ADDENDUM NO. 2 TO CONTRACT DOCUMENTS

Project: Southeast Regional Lift Station H&S Project No. 32394-001
Contract 2
Phase I Pipelines

Owner: City of Durham Date: July 19, 2019

Addendum No. 2

C-128 – ABANDON GRAVITY SEWER AND FORCE MAIN

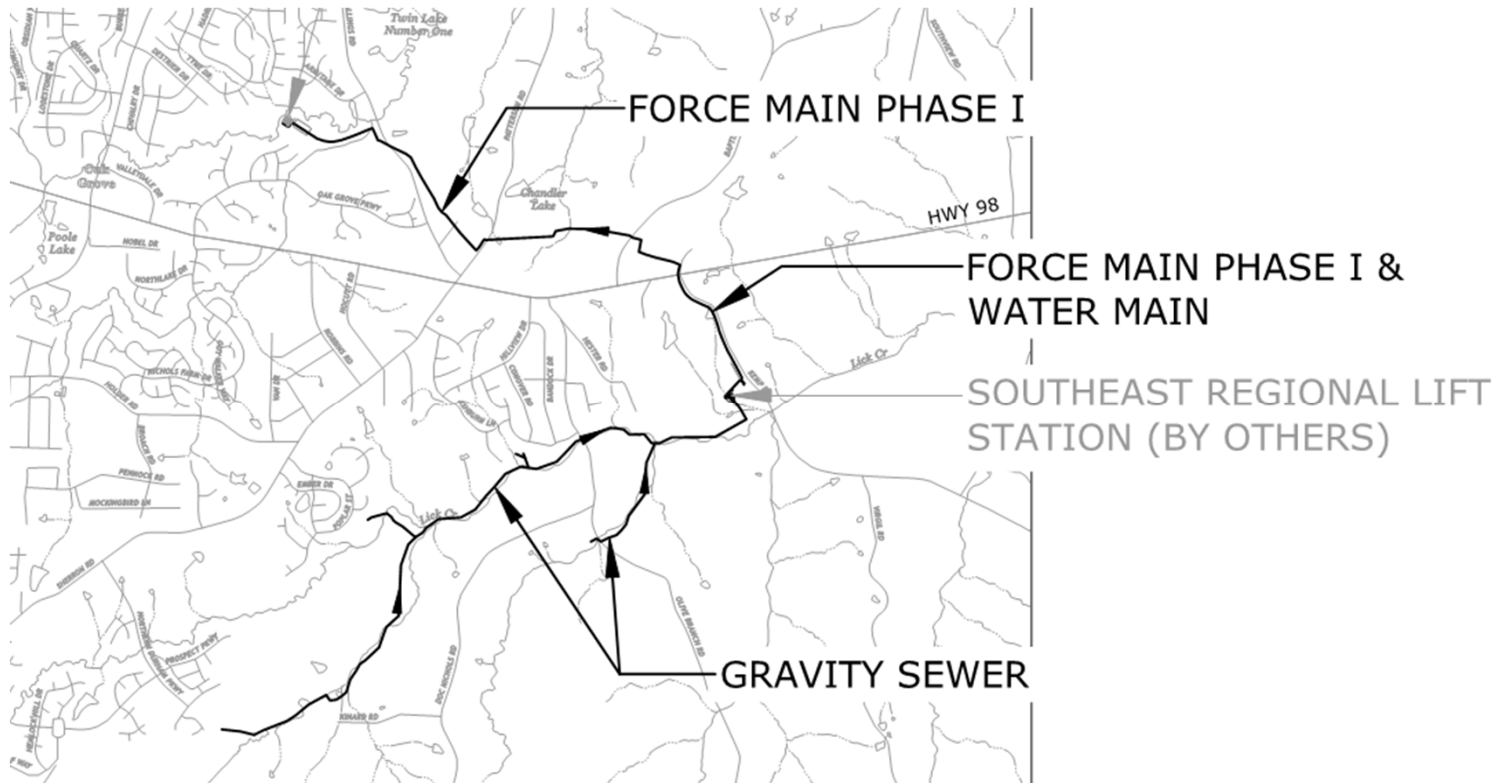
- *The Contractor shall note that 4 of the 46 manholes to be abandoned are shown on this sheet.*
